Errata to MPC8572E PowerQUICC™ III Integrated Processor Reference Manual, Rev. 2

This document describes substantive changes to the *MPC8572E PowerQUICC™ III Integrated Host Processor Reference Manual*, revision 2. For convenience, the chapter number and section number of the errata item in the reference manual are provided. Items in bold are new since the last revision of this document.

Figure 10-43. Messaging Interrupt Destination Registers (MIDR_n)

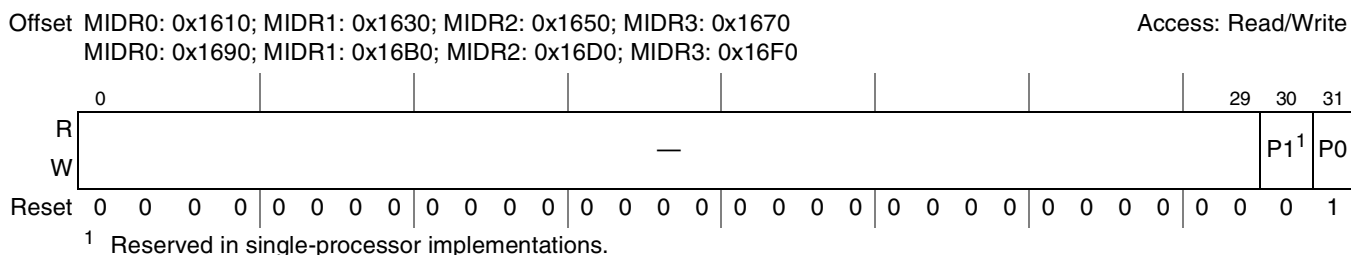
In Figure 10-43, “Messaging Interrupt Destination Registers (MIDR_n),” and Table 10-43, “MIDR_n Field Descriptions,” make bits EP, CI0 and CI1 reserved, as follows:

Figure 15-47. MII Mgmt Control Register Definition

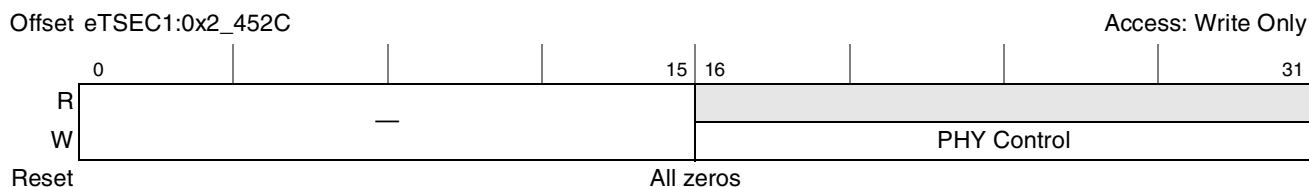
15.5.3.5.9, 15-83 Replace Figure 15-47, “MII Mgmt Control Register Definition,” with the following figure that has been updated to show write-only access:

Figure 20-18. PCI Express Outbound Window Attributes Registers 1, 2, 4 (PEXOWAR n)

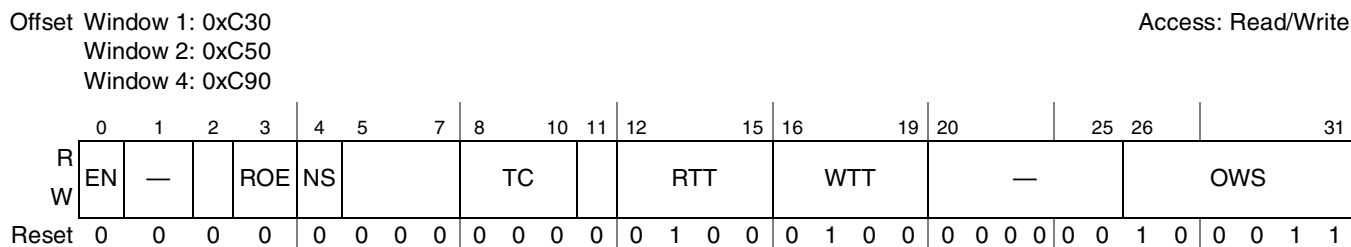
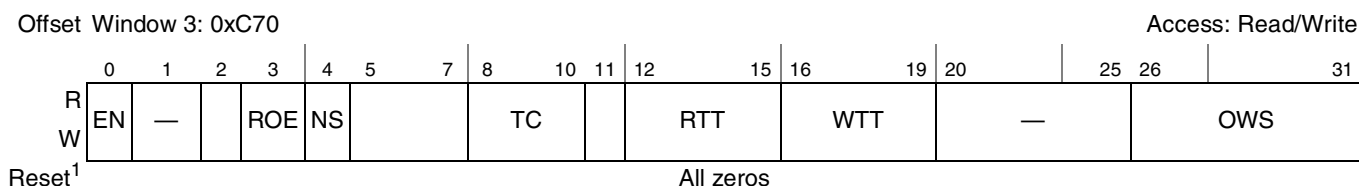
21.3.5.1.4, 21-23 Replace Figure 21-18, “PCI Express Outbound Window Attributes Registers 1–4 (PEXOWAR n),” with the two following register figures:

¹ If the device is configured to use the alternate boot vector (cfg_boot_vec = 0), the reset value for PCI controller 1 PEXOWAR3 is 0x8004_400F. If the device is not configured to use the alternate boot vector (cfg_boot_vec = 1), the reset value for PCI controller 1 PEXOWAR3 is 0x0000_0000.

21.3.5.1.4, 21-23 Add the following footnote to Figure 21-18, “PCI Express Outbound Window Attributes Register 1–4 (PEXOWAR n): “The reset value for PCI controller 1 PEXOWAR3 is 0x0000_0000.”

Figure 23-6. POR Device Status Register 2 (PORDEVSR2)

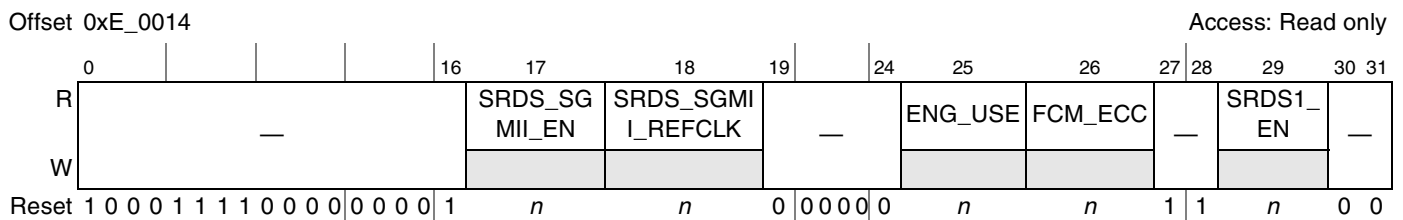
23.4.1.6, 23-12 Update the reset value for Figure 23-6, “POR Device Status Register 2 (PORDEVSR2),” as follows:
